UNITED STATES PATENT AND TRADEMARK OFFICE

Office Action Summary	Application No. 10/633,368	Applicant(s) LAYTON ET AL.
	Examiner Amy J. Sterling	Art Unit 3632

This is a non-final Office Action for application number 10/633,368 Shock-Resistant Enclosure, filed on 7/31/03. Claims 1, 2, 4-35 are pending. Claims 4, 13, 15, 16 and 26-31 are withdrawn. This non-final Action is in response to applicant's Appeal Brief dated 4/12/07. The text of those sections of Title 35, U.S. Code not included in this action can be found in a prior Office action.

Claims 10-12, 17 and 18 are rejected under 35 U.S.C. 103(a) as being unpatentable over United States Patent No. 6454250 to Ribeiro.

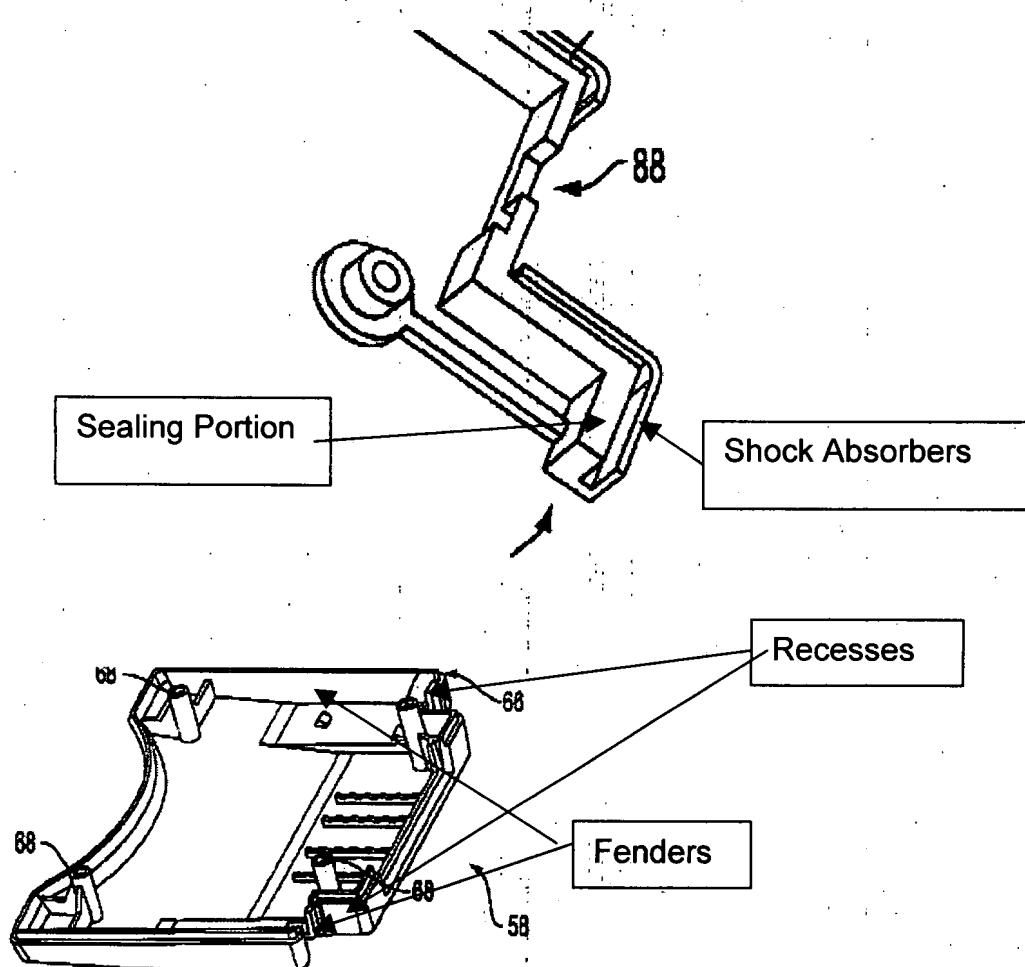
The patent to Ribeiro discloses a shock-resistant enclosure (54, 56, 58) having a base (58) and a cover section (56), and a combined sealing gasket (54) and shock absorbing structure formed integrally of an elastomeric material (See Col. 3, line 63) with a generally planar sealing portion (92) disposed between the base and cover sections of the housing and a plurality of discrete shock absorbing elements (76, 96) extending outwardly from the sealing portion and projecting from different sides of the housing with at one of the elements projecting from the housing in a direction substantially perpendicular to the plane of the sealing portion, wherein the shock absorbing elements are connected to the sealing portion by runners (78, 80) which are embedded in the walls of the housing and in recesses near the corners of the housing and held in place by corner pieces retained by fasteners (60) that also hold the base and cover sections of the housing together.

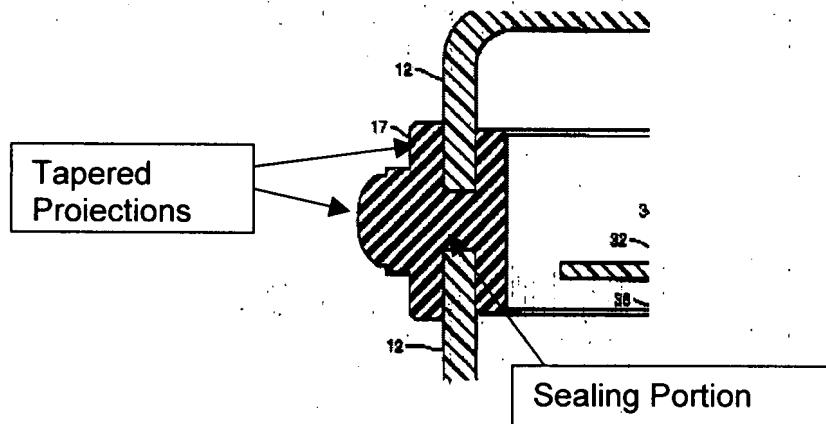
The patent to Crockett discloses a shock-resistant enclosure (10) having a housing with a base (18) and cover (16) section, to which a fragile element (14) is rigidly mounted and a combined sealing gasket and a generally planar shock absorbing structure formed integrally of elastomeric material (See Co. 4, lines 21 for material, silicone rubber is considered an elastomer) with a sealing portion (See Drawing Below) disposed between the base and the cover sections of the housing and plurality of

discrete shock absorbing elements (17, See Drawing Below) extending from the sealing portion and are projecting from the different sides of the housing, the projections which are tapered and decrease in cross-sectional area away from the housing and are projecting outwardly in different directions from the housing.
